MOONEY AIRCRAFT, INC.

SERVICE LETTER 20-74

SERVICE BULLETIN M.20-74

DATE: August 17, 1960
SUBJECT: Fuel Quantity Gauge -- Main Tanks
MODELS AFFECTED: M20 and M20A All Serial Numbers
TIME OF COMPLIANCE: As soon as possible

FIGURE 1

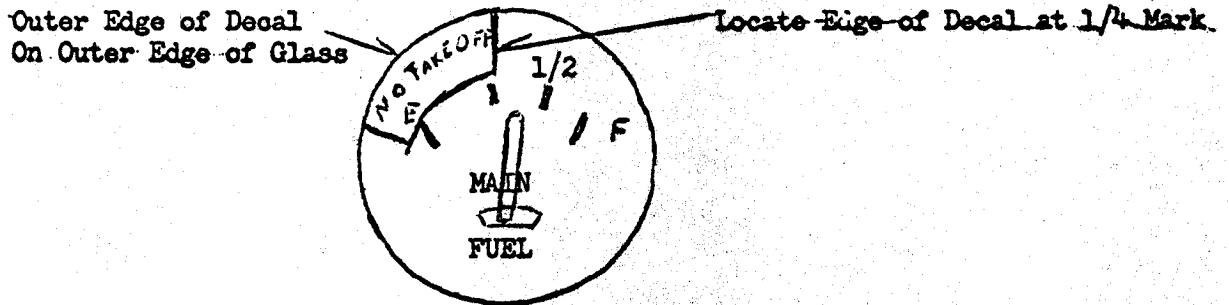
A "No Take Off" decal is enclosed at no charge for application to your main tank fuel gauge. This decal serves as a necessary reminder that the last 1/4 tank of fuel is not recommended for take-off. Unsuccessful take-offs have occurred due to the pilot misreading the fuel quantity gauge, reading 1/4 tank when the tank is empty, and not making a physical check of tanks prior to flight.

- 1) Clean Fuel Quantity Gauge glass cover
- 2) Soak decal in water for about 30 seconds or until tissue is loose and decal will slide on backing card.
- 3) Apply decal as shown in Figure 1 and remove excess water with blotter.
